Proposal for amendments to Regulation No. [151] (Blind Spot Information Systems for Heavy Vehicles)

The text was reproduced below was prepared by the experts from the International Organization of Motor Vehicle Manufacturers (OICA) to amend the test method. The modifications to the existing text of the draft Regulation (see ECE/TRANS/WP.29 /2019/28) are marked in bold for new or strikethrough for deleted characters.

Figure 1
Dynamic tests

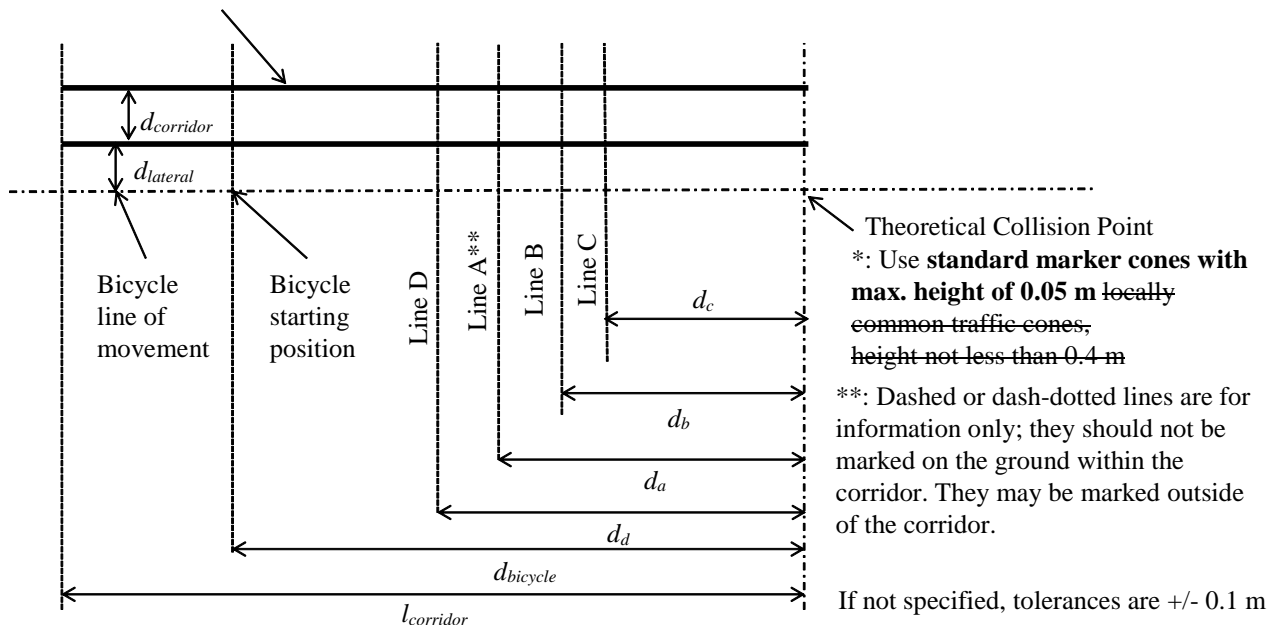
Appendix 1, figure 1, amend to read:

Mark corridor using cones *, spacing ~~not more than~~ **2.5 - 5 m**

1. Not warning for static objects, like traffic cones, is an important part of the properties of the blind spot regulation. However, as the current test specification was written, the cones, because of their height, may obstruct the view of the system towards the bicycle. That would prevent the system from tracking the moving bicycle dummy and thereby make the system fail the test. This is even more likely to happen if the cones are placed within a short distance from each other.
